THE CINCINNATI GAS & ELECTRIC COMPANY

RE: WM. H. ZIMMER NUCLEAR POWER STATION
UNIT 1 - CONSTRUCTION WORK
APPROVAL REQUEST (CWAR) NO. 98, REVISION 1
W.O. 57300, JOB E-5590, FILE NO. 956C,

Construction Work Approval RequestCWAR Number 98, Rev. 1Contractor/Organization Foothill Electric CorporationItem Wire Ties Installed On Kellum GripsSystem I.D. All Systems

THE CINCINNATI GAS & ELECTRIC CO.
WM. H. ZIMMER NUCLEAR POWER STATIONDDC NO. E-8139REV. PAGE 1 OF 1

**CABLE PAN & CONDUIT
RISER CABLE SUPPORTS
TYPICAL**

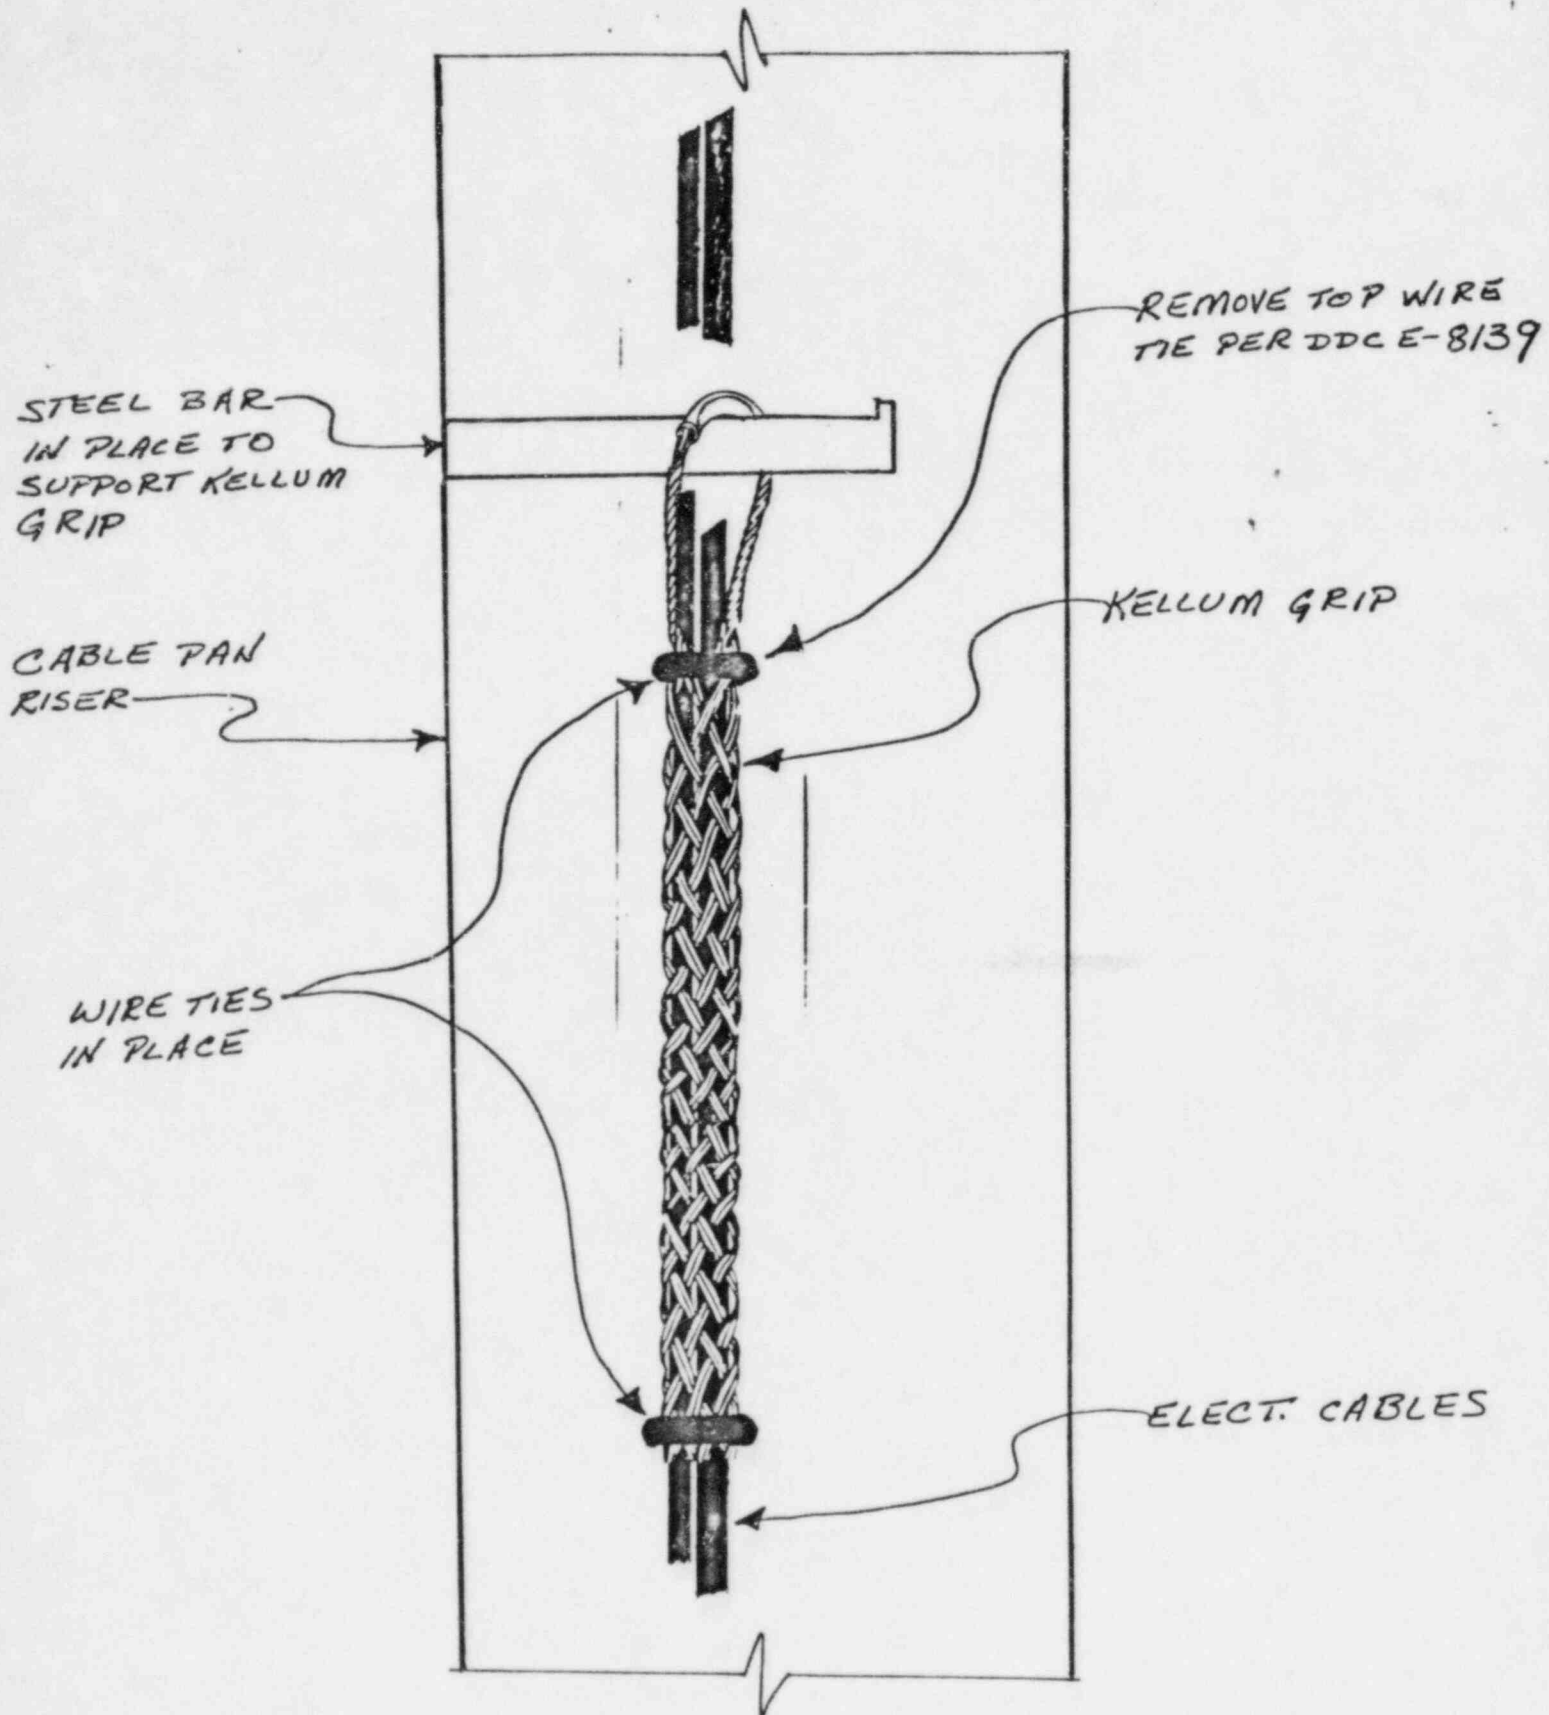
For inspection purposes the minimum acceptable length of support weave shall be 90% of dimension "M" for a given circumference or diameter range indicated in Standard EB-200.

Drawing E-13, sheet 1, Note 8. Requirement for installation of wire tie at the top of cable grips shall be removed. All previous installations shall have the top wire tie removed.
